To: **Planning Reps**
From **Highways Development Management Officer**

Your Ref 20221080
Location 12 Cruden Road, Gravesend, Kent, DA12 4HD

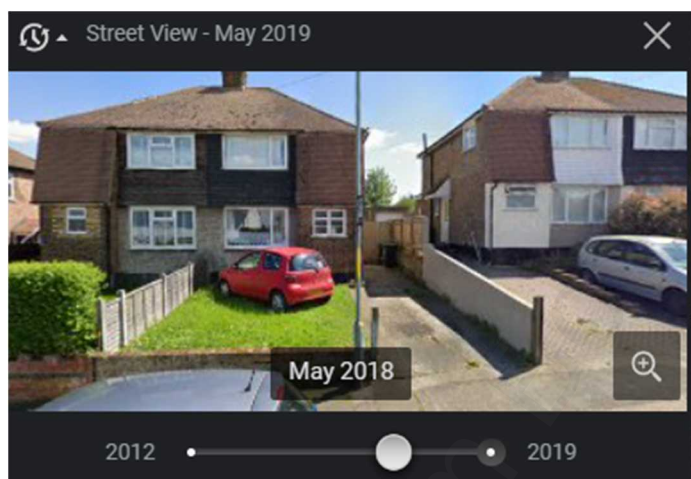
I note there is no increase in the number of bedrooms, so there is no need to alter the car parking provision, it being impossible to park a vehicle adjacent to the building whilst maintaining a pedestrian route to the property.

The May 2018 Google Street View image demonstrates that vehicles would be parked on the grass rather than adjacent to the building.

The width of the front garden appears to be less than the 7.9 metres required given in the guidance in SPG4. 2.7m + 2.5m + 2.7 m

See note 2 last sentence

The proposed parking plan should be therefore reduced to two parking spaces and as it may require the relocation of a lamp column, which can be a costly exercise, the carriage crossover should be constructed prior to the alterations to the main dwelling.

There should be no boundary treatment, hard or soft landscaping over 850mm in height within 2 metres of the highway boundary, (back edge of footway) to protect pedestrian visibility splays.
